Access Compliance Report

Public Rights-of-Way

Intersection ID: 29983	Main Street: REAMES_RD	Cross Street: SILVER_GARDEN_LN	Location: NE
ADA ID: 8E10CB284277	Ramp Type: Perpendicular	Initial Pass/Fail: Fail	Overall Compliance: No
			Severity Score: 13.75

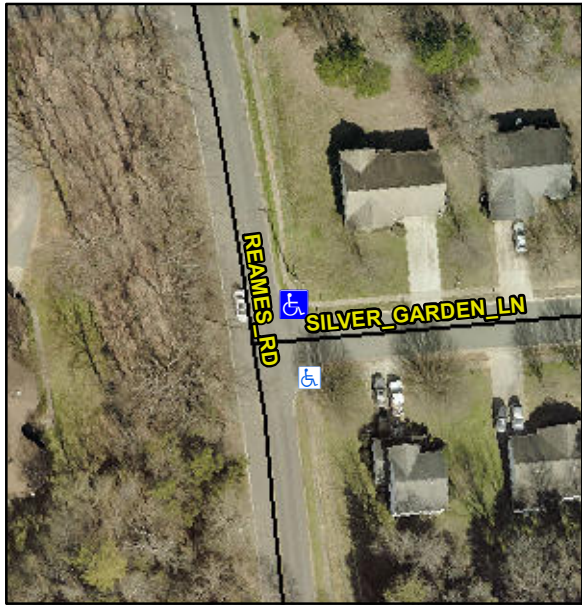
Codes/Mitigation Info/Possible Solution			Field Measurements/Component Compliance					
	Possible Solutions:		Compliance	Description	Data	Compliance	Description	Data
	Remove & Replace Entire Ramp.		N/A	Ramp Length (in)	100.0	No	Ramp Slope (%)	9.6
			Yes	Ramp Width (in)	48.0	No	Ramp XSlope (%)	2.8
			N/A	Flare Type LT	N/A	N/A	Flare Type RT	N/A
			N/A	Flare Slope LT (%)	N/A	N/A	Flare Slope RT (%)	N/A
			N/A	Flare Traversable LT?	N/A	N/A	Flare Traversable RT?	N/A
			N/A	Landing Length (in)	N/A	N/A	DWS Provided?	N/A
			N/A	Landing Width (in)	N/A	N/A	DWS Contrast?	N/A
			N/A	Landing Slope (%)	N/A	N/A	DWS Length (in)	N/A
			N/A	Landing X Slope (%)	N/A	N/A	DWS Full Width?	N/A
Surveyor Notes:		N/A	N/A	Landing Curb? (Y/N)	N/A	N/A	DWS Offset (in)	N/A
PROW/ADA:		Not Found, R304.2.2, R304.5.3	N/A	Shared Landing?	N/A	N/A	Gutter Slope (%)	N/A
			N/A	Gutter Ponding?	N/A	N/A	Gutter X Slope (%)	N/A
			N/A	Gutter Lip Ht (in)	N/A	N/A	Gutter X Slope (%)	N/A

N/A	Painted X Walk1?	No	N/A	Painted X Walk2?	N/A
				X Walk 1 Direction	To S		X Walk 2 Direction	N/A
			N/A	X Walk 1 Width (in)	N/A	N/A	X Walk 2 Width (in)	N/A
				X Walk 1 Slope (%)	2.7		X Walk 2 Slope (%)	N/A
				X Walk 1 X Slope (%)	5.5		X Walk 2 X Slope (%)	N/A
			N/A	Ramp inside XWalk1?	N/A	N/A	Ramp inside XWalk2?	N/A
				Road Slope (%)	N/A	N/A	Clear Space?	N/A
				Road X Slope (%)	N/A	N/A	Clear Space to XWalk (in)	N/A
			N/A	Any Obstructions?	N/A	N/A	Storm Grate/Utility Hazard?	N/A
				Obstruction Type			Storm Grate/Utility Type	
					N/A			N/A
						Yes	Surface Condition? (G/P)	Good
					</
